**CLARKE COUNTY PLANNING COMMISSION  
TABLE OF CONTENTS  
June 2019 Combined Meeting Packet**

**SITE PLAN AMENDMENT (SP-18-02)**

**STAFF REPORT – Department of Planning**

**HANDY MART DIESEL PUMP EXPANSION**

DATE:	06-11-2018
SCALE:	1" = 25'
DESIGNED BY:	NTA
FILE NO.	4515F-2
SHEET	6 OF 15
DWG #	18-10

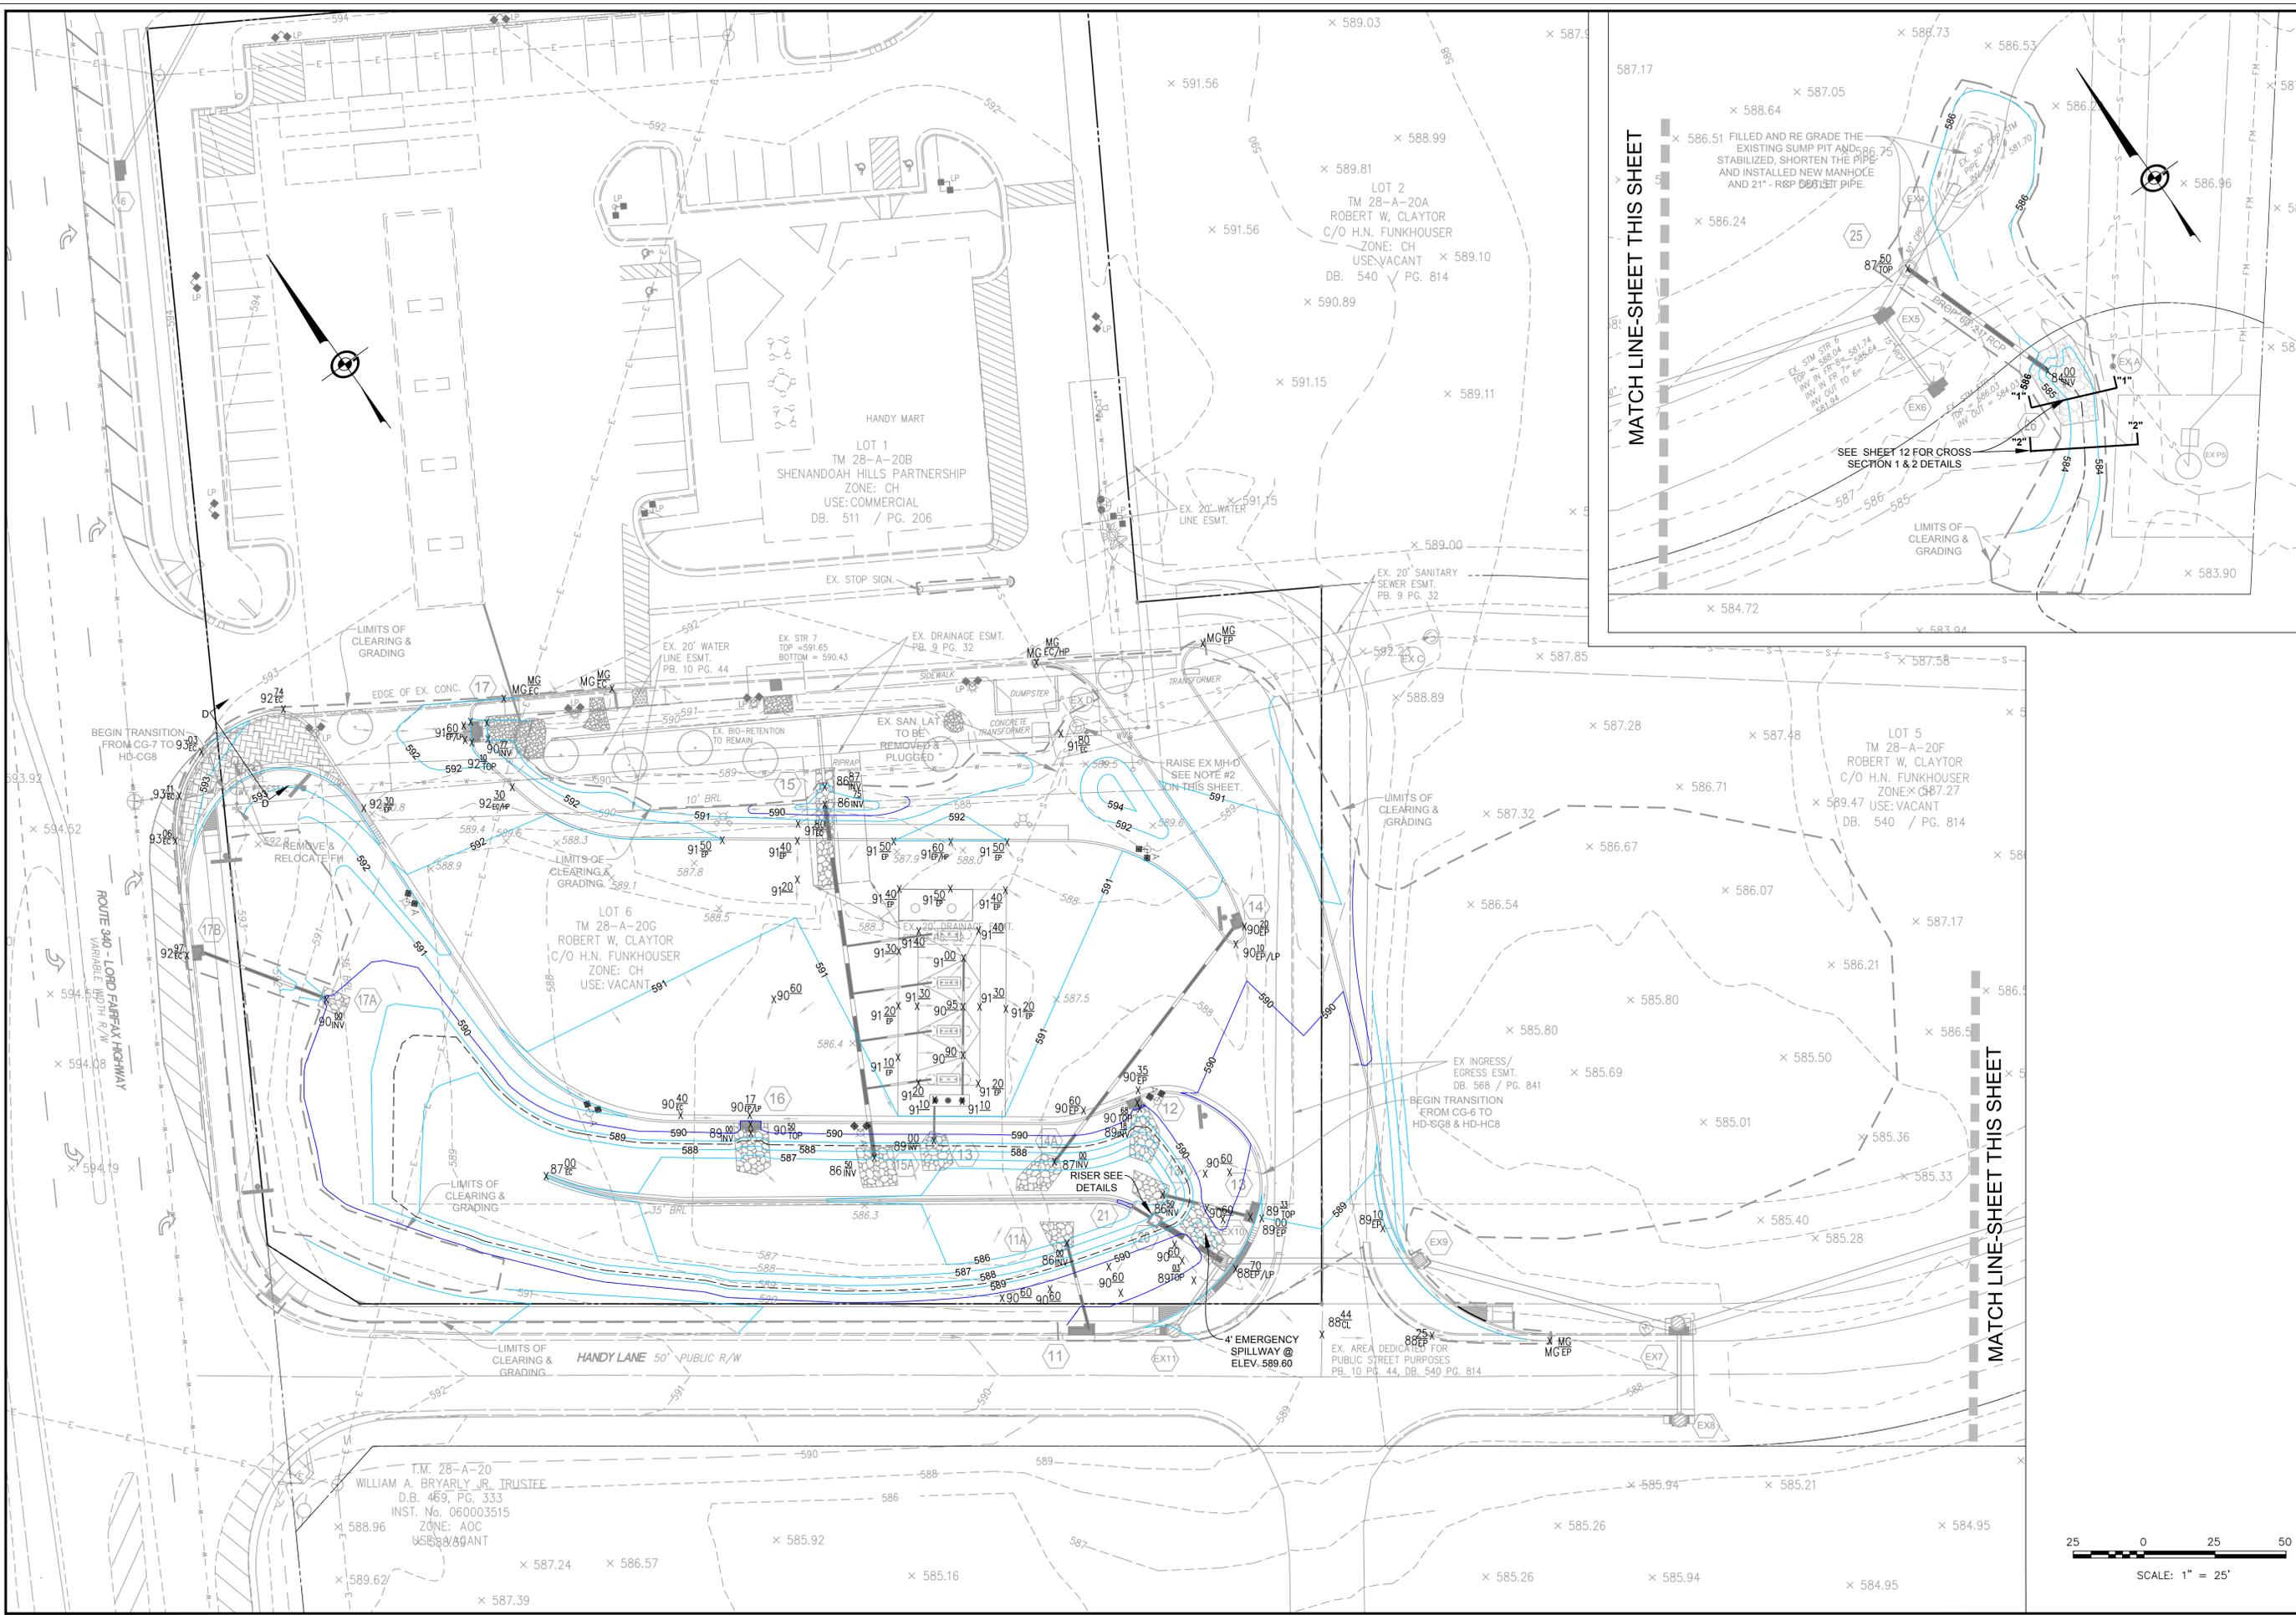
**Comment 5:** *Sheet 6: The Elevation is missing from the note regarding the Geo-membrane liner.*

Response: The notes have been added to sheet 6. See notes 4, 5, & 6.

Response: See note 2 on sheet 6.

Response: See note 7 on sheet 6.

**Response:** Elevation on pond liner is added and coordinated see sheet 6.

SHEET 8 OF 15

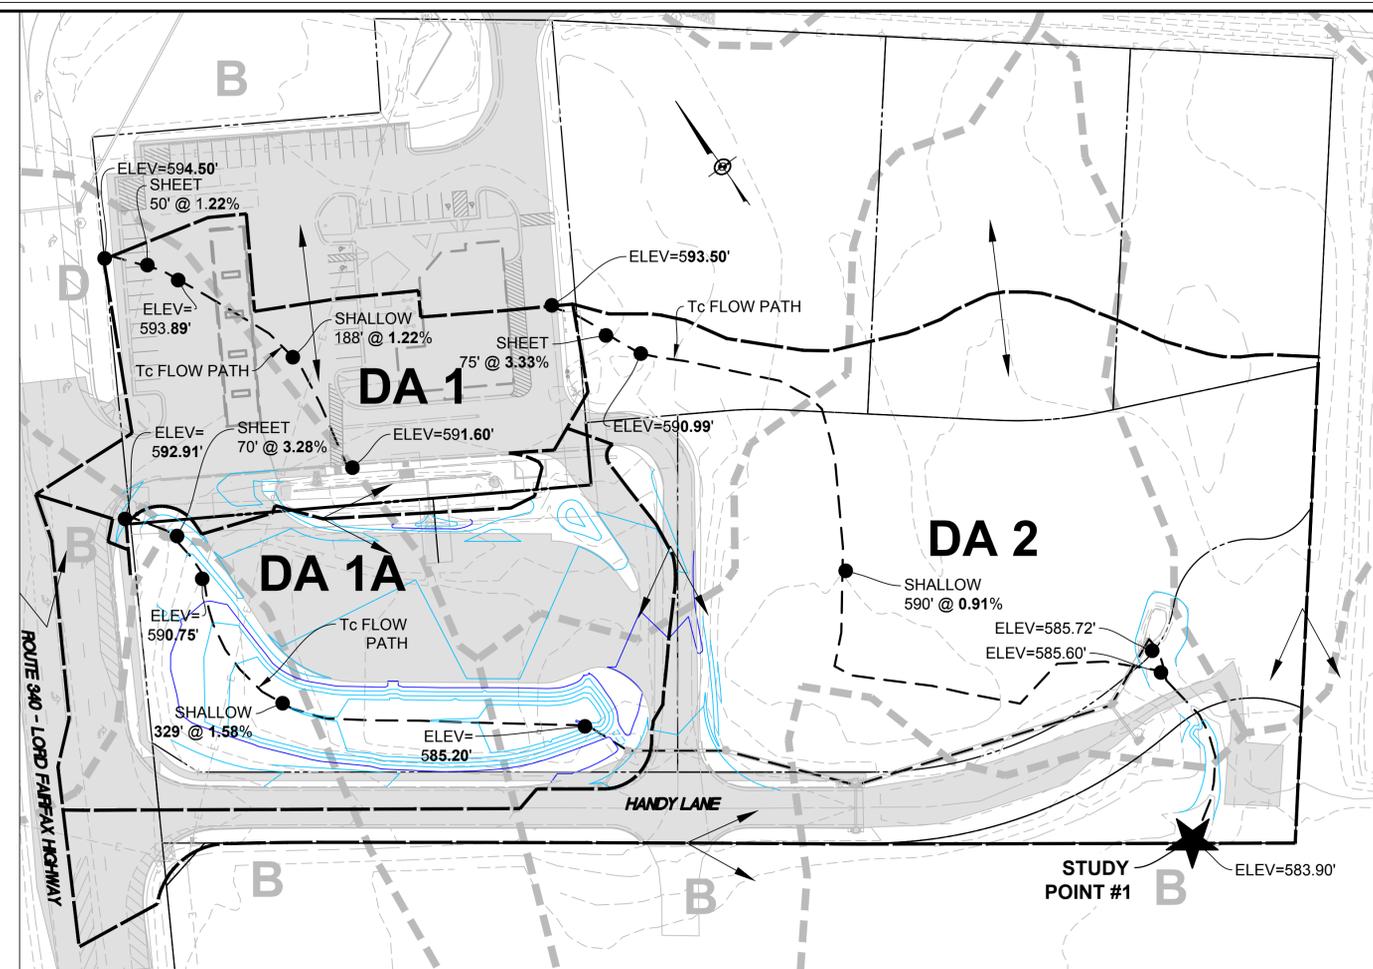
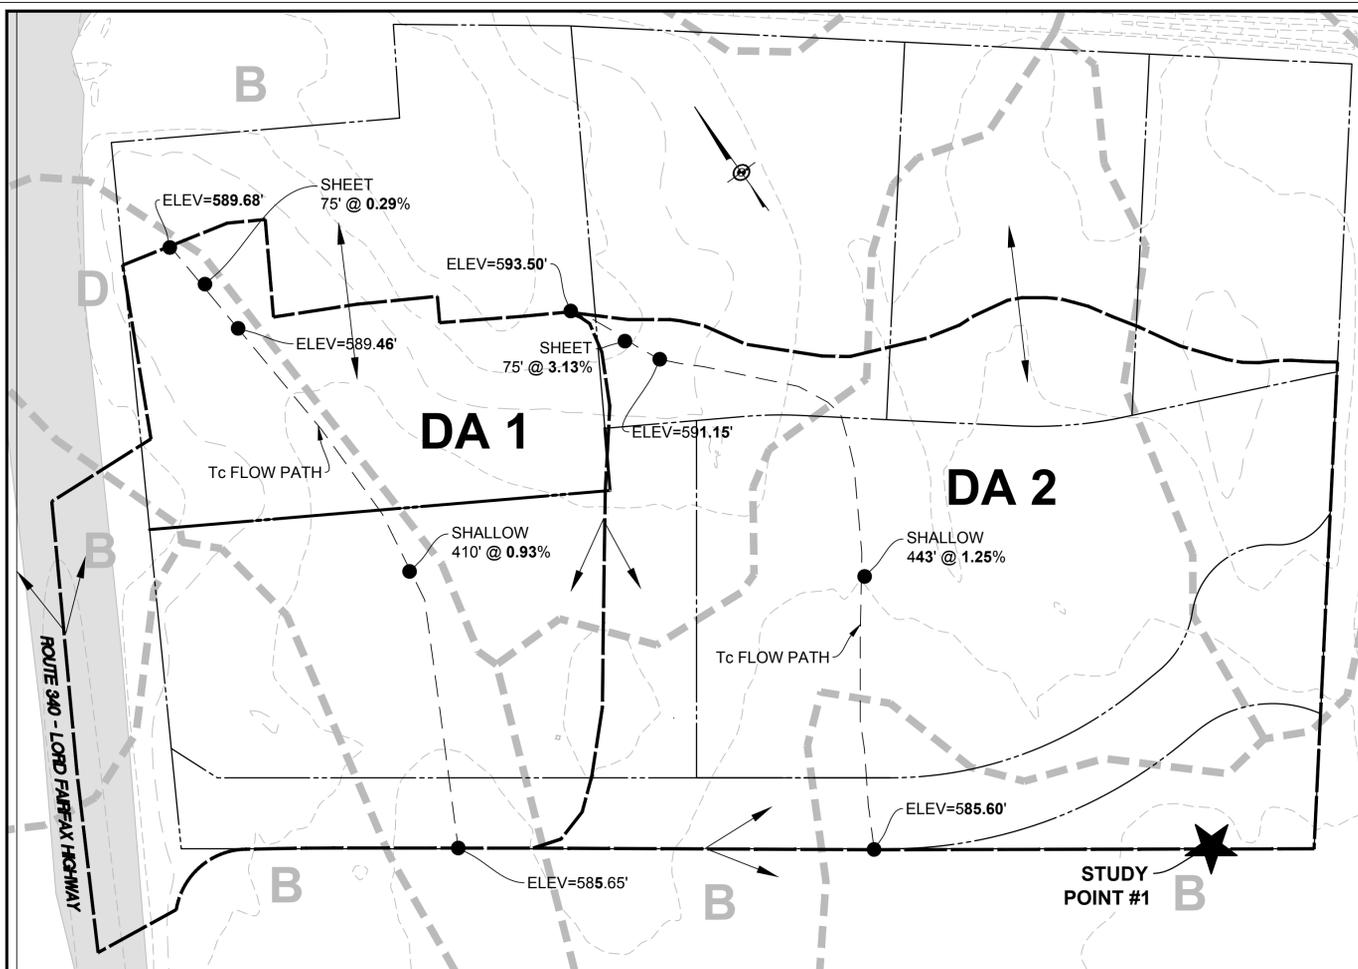
**Comment 7:** *The Water Quality calculations for this project are based on an applicable area of 3.25 acres. The Hydrographs provided show an area of 3.301 acres. Sheet 8 of the planset shows a Water Quality Area of 2.61 acres. Please clarify the applicable areas for this site.*

**Comment 8:** *The Water Quality Calculations shown on Sheet 8 of the plan set do not match the Calculations within the Stormwater Management Report. Please Correct.*

**Response:** The 3.301 acres is the total drainage area to the SWM Basin. The 3.25 acres is the applicable area for the water quality computations. Sheet 8 has been corrected and now shows 3.25 acres.

**Response:** Sheet 8 has been updated and now matches the SWM Report.

SHEET 14 OF 15

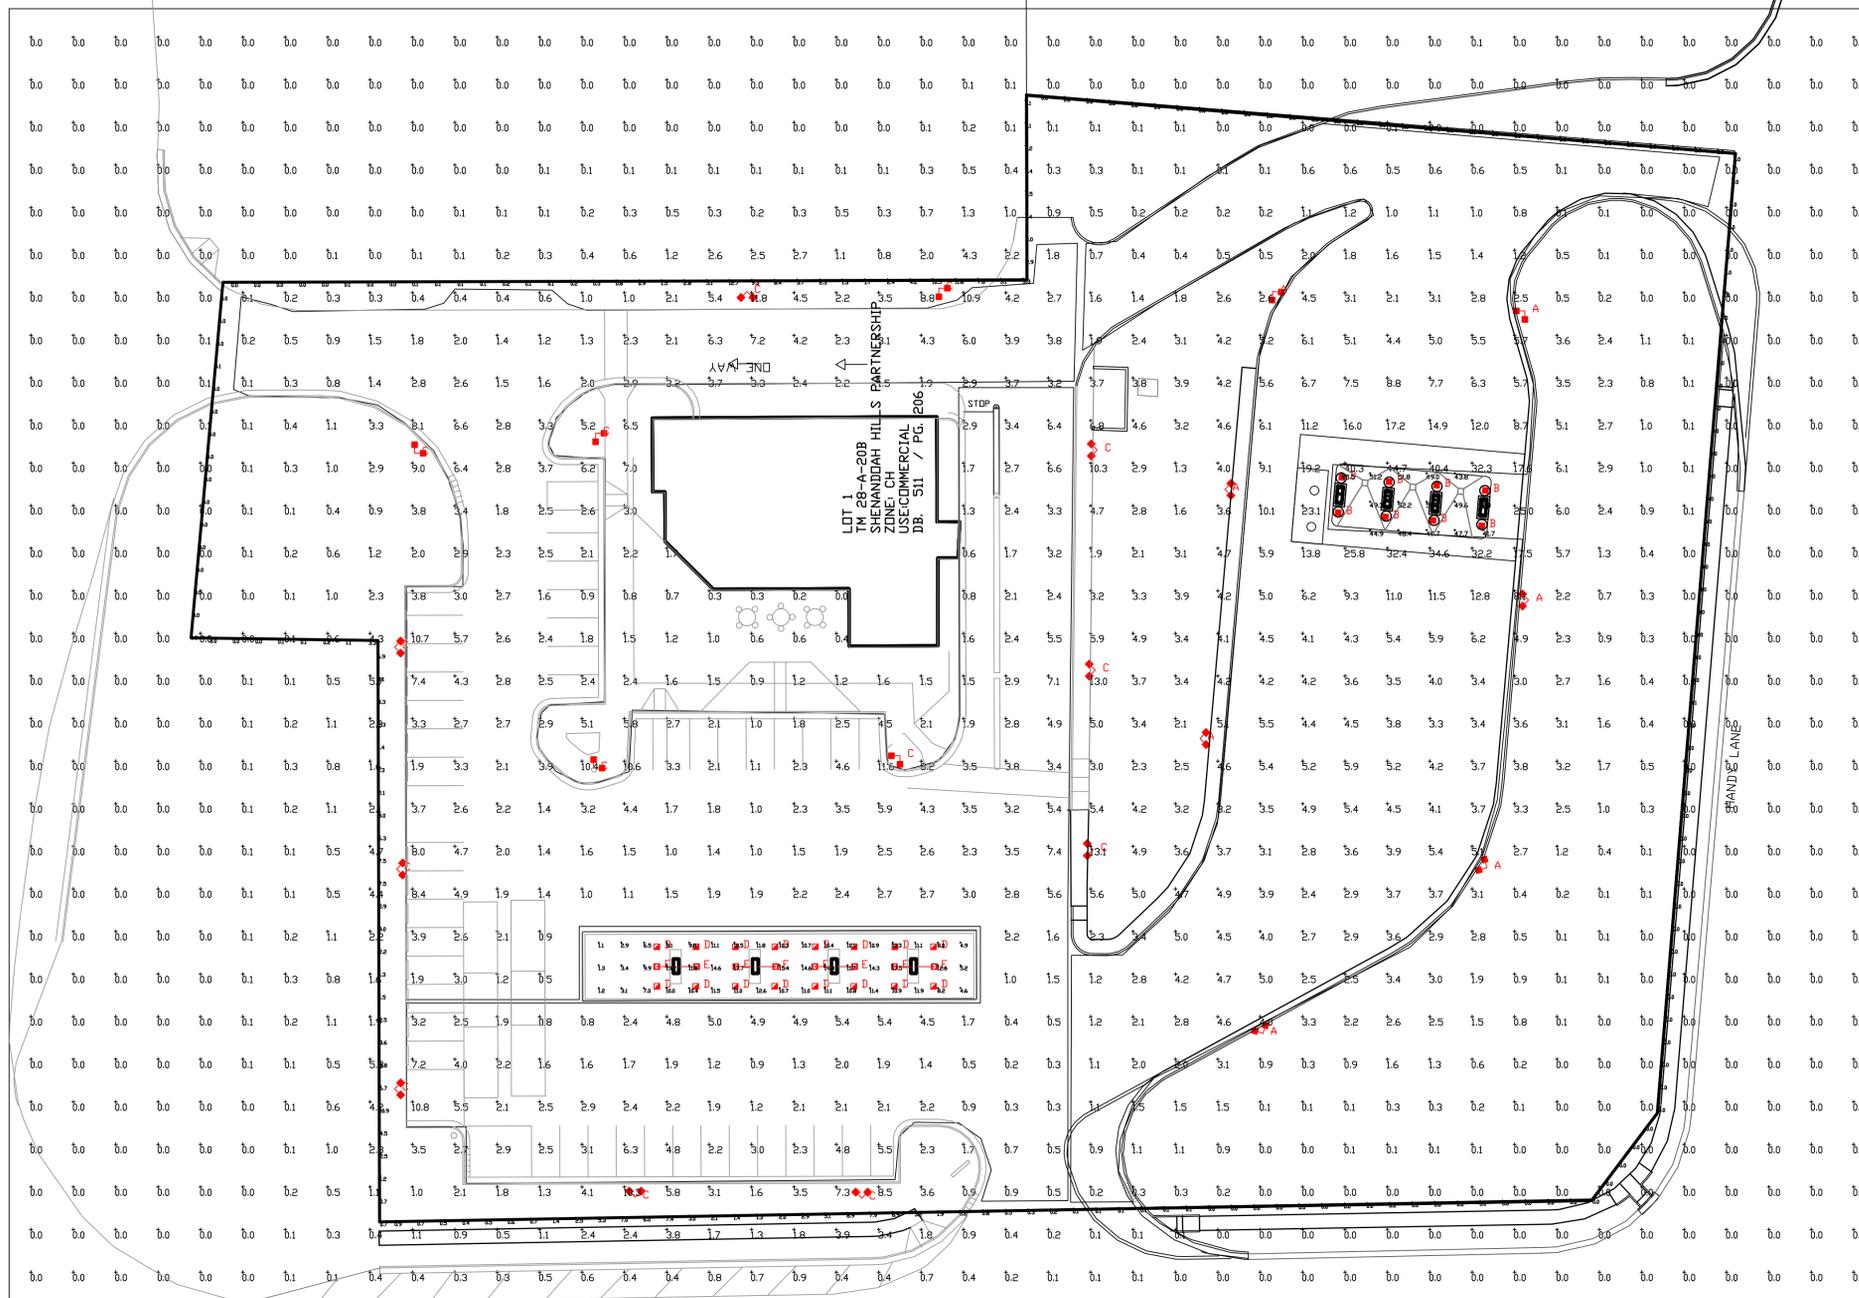
**Comment 15:** Sheet 14: Landscaped plantings are shown within the dam embankment of the pond. Please remove.

**Response:** As discussed, the proposed trees located in filled embankment area are removed and replanted elsewhere within the site see sheet 14.
